Flight Procedures Cover Page	Task Action: FLIGHT CHECK	Task Type: STAR	Estimated Chart Date: 05/21/2020	APWS Task ID: 4E3AD4EFBE724DDDB838A9BC7CBA94C27	APWS Request ID: BB930EAC17E74D27AC9AB981EAB35523
Procedure: RNAV STAR APPLE ONE LAGUARDIA NY LGA		Enroute: YES	Specialist: Donahue, Liam		Agreement Number:
Airport ID: KLGA	Airport Name: LAGUARDIA		Airport City: NEW YORK		State: NY
Facility ID:	Facility Type:	Flight Inspection Remark Type: New FC Slot			
<div>Procedure Comments:</div> <div>Approval letter for Termination fix without a published or mandatory altitude.</div> <div>CONTACT: DON LANIER, AJV, A431 MANAGER, 405.954-8242</div> <div>01/30/2020</div> <div>QUALITY 14 CHECKED</div>

Subject: Approval Request: Laguardia Airport, New York, NY (KLGA)

APPLE (RNAV) Standard Terminal Arrival Route (STAR), VADDR Terminus

PROCEDURE REVIEW BOARD (PRB) RESULTS

APPLE1 (RNAV)

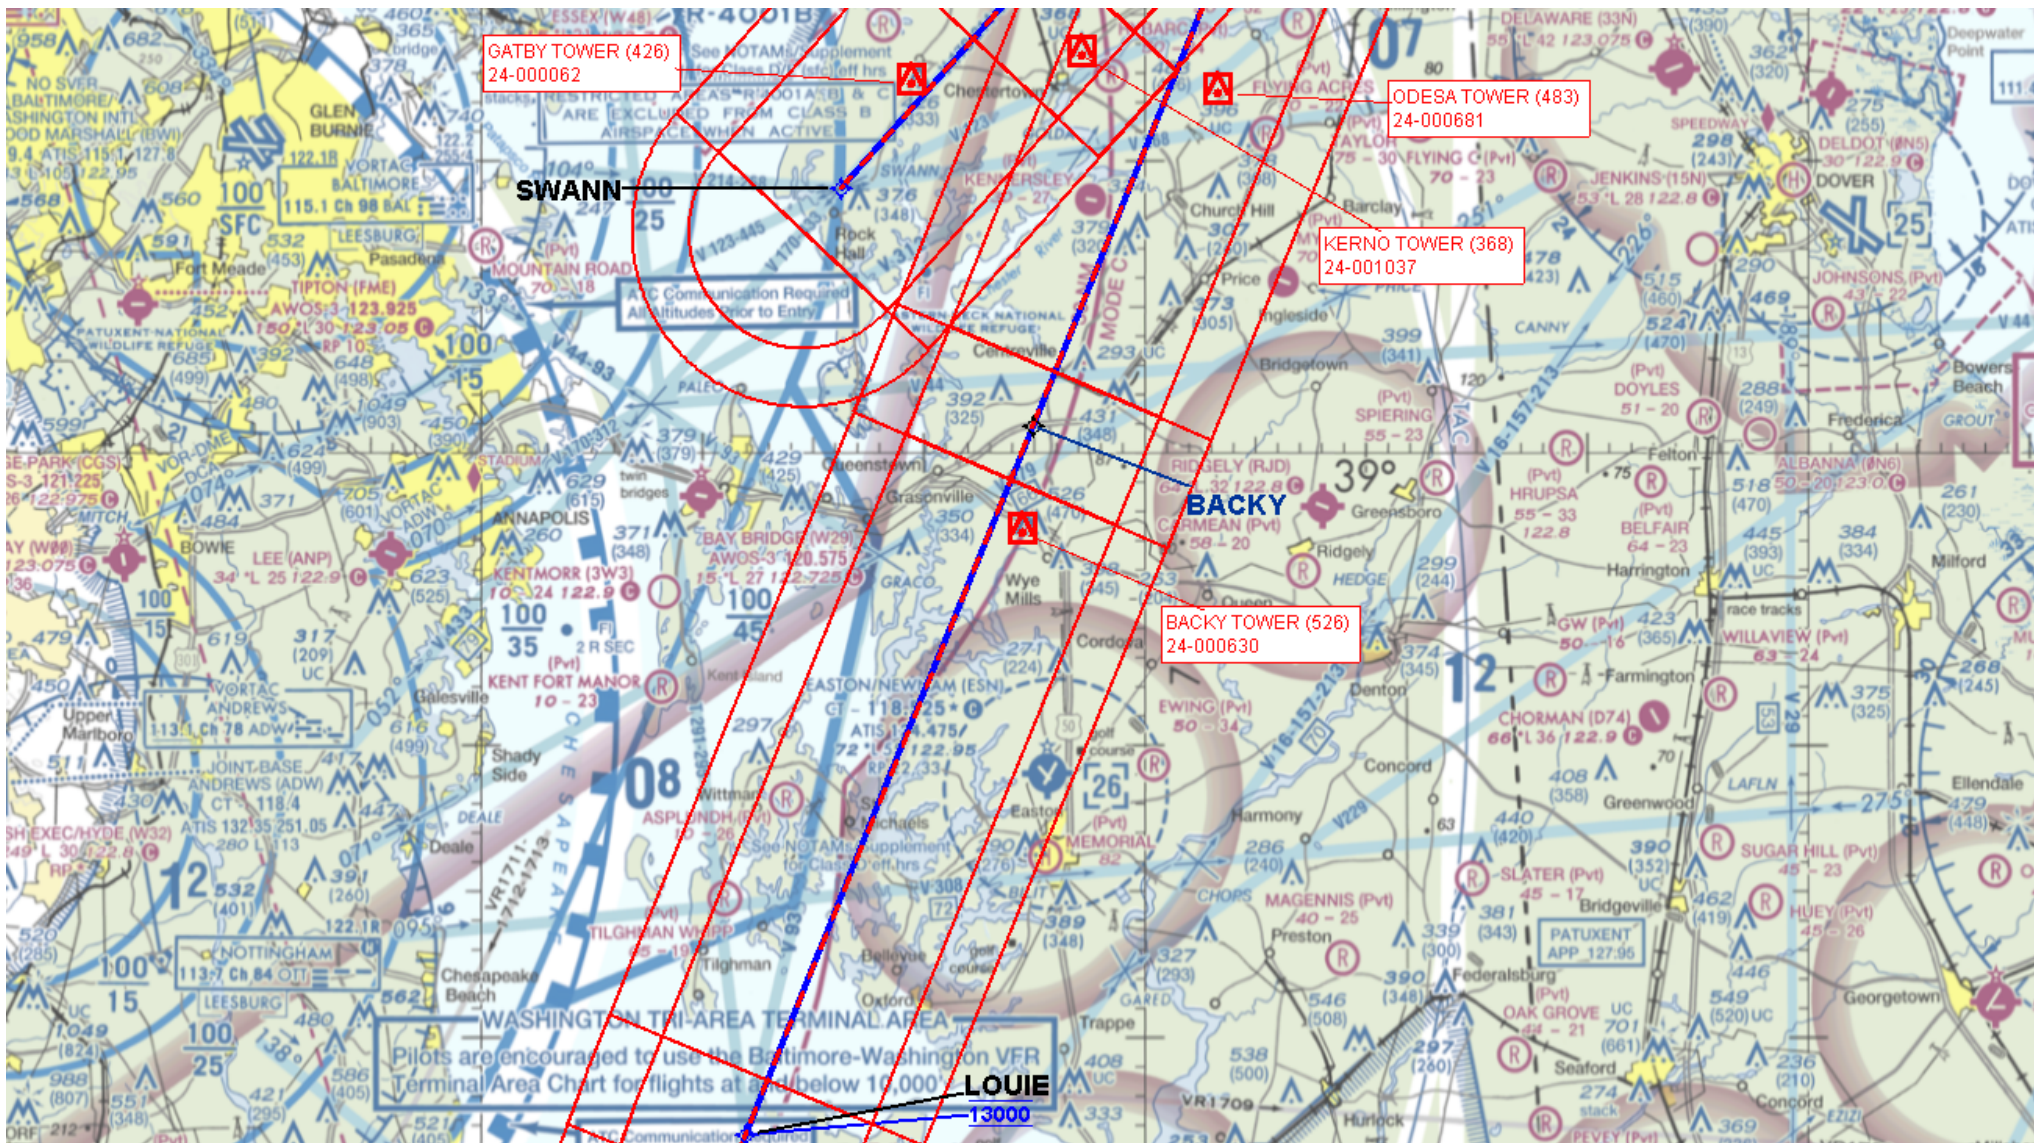
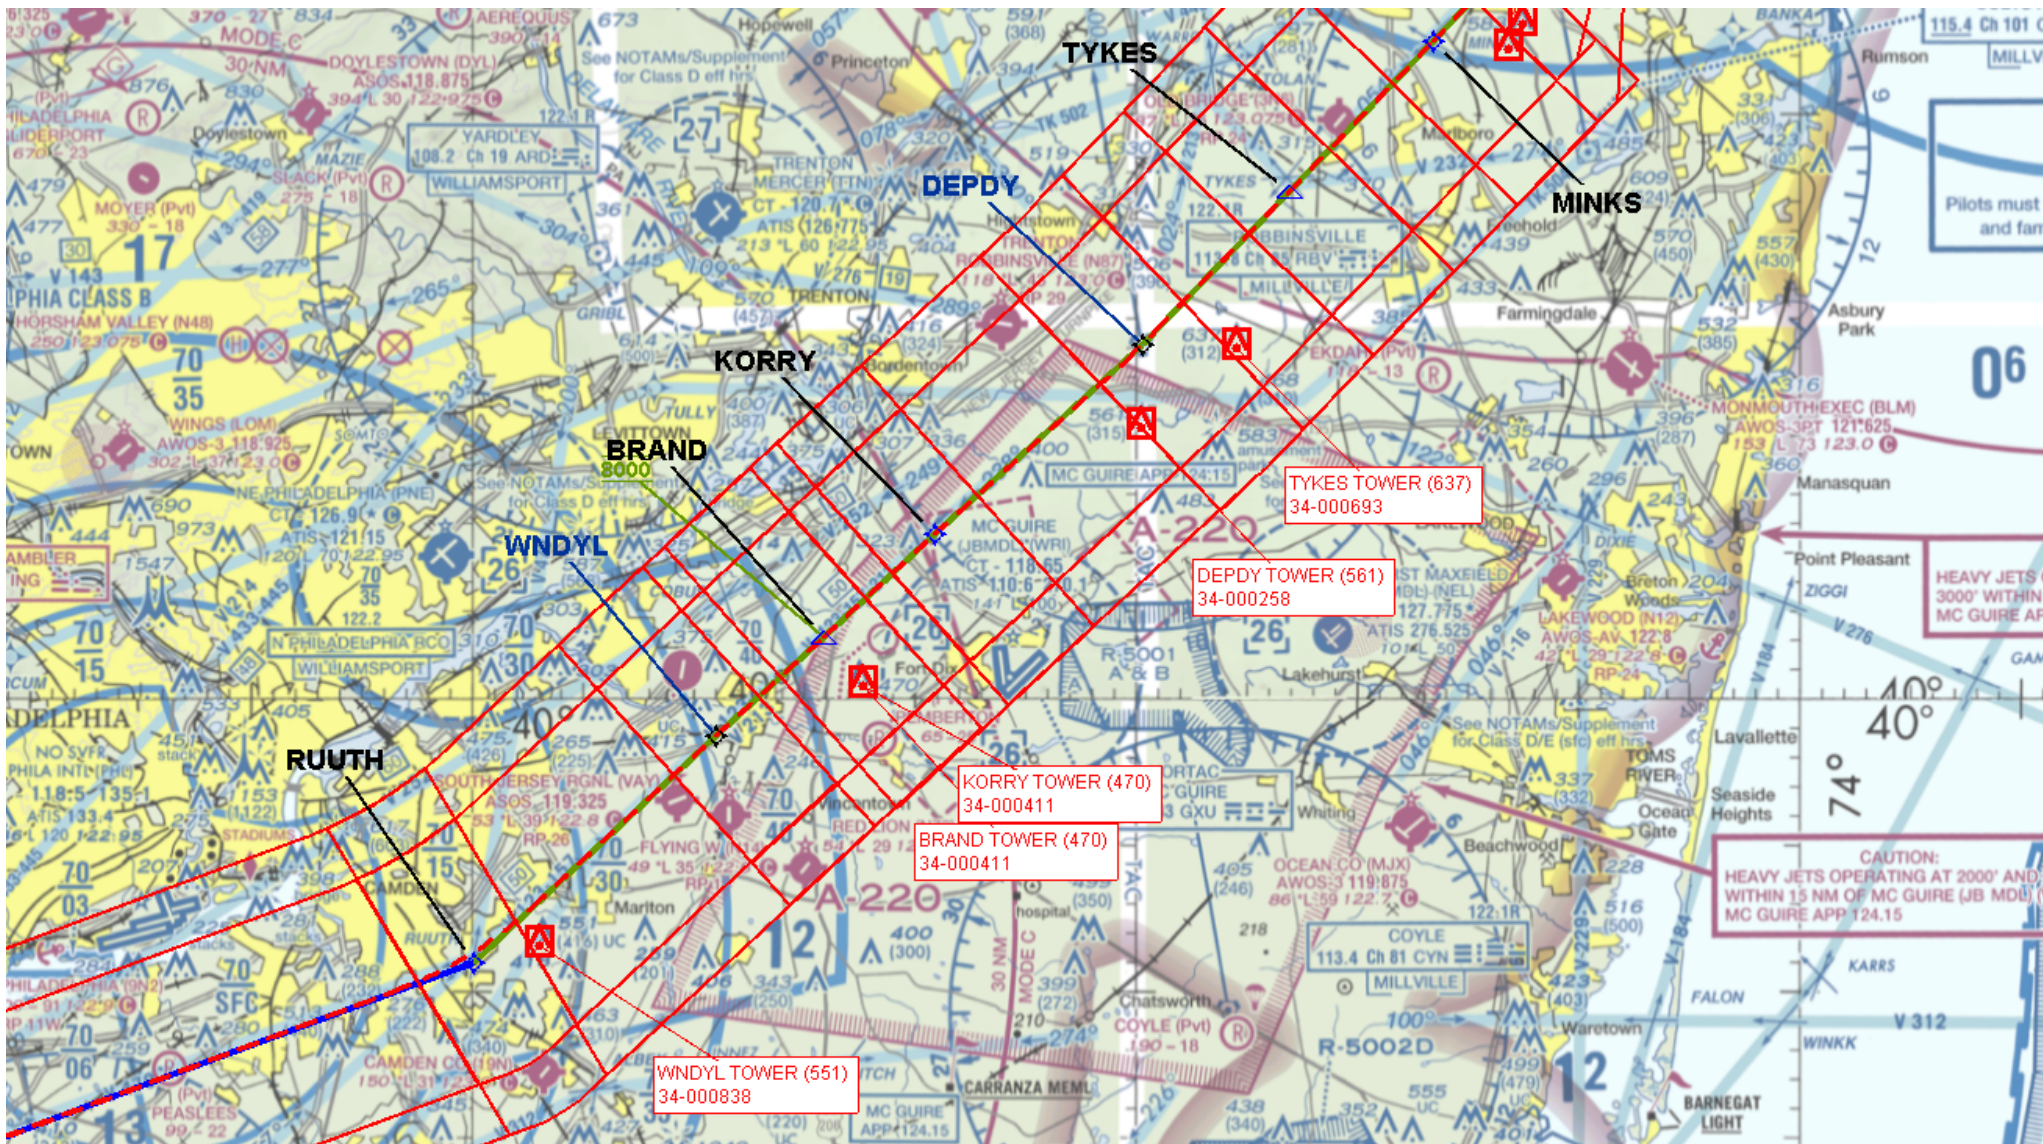
c. Graphic depiction/FIG 210 KT ICON not charted at DQO and KERNO.

Will be corrected on final publication.
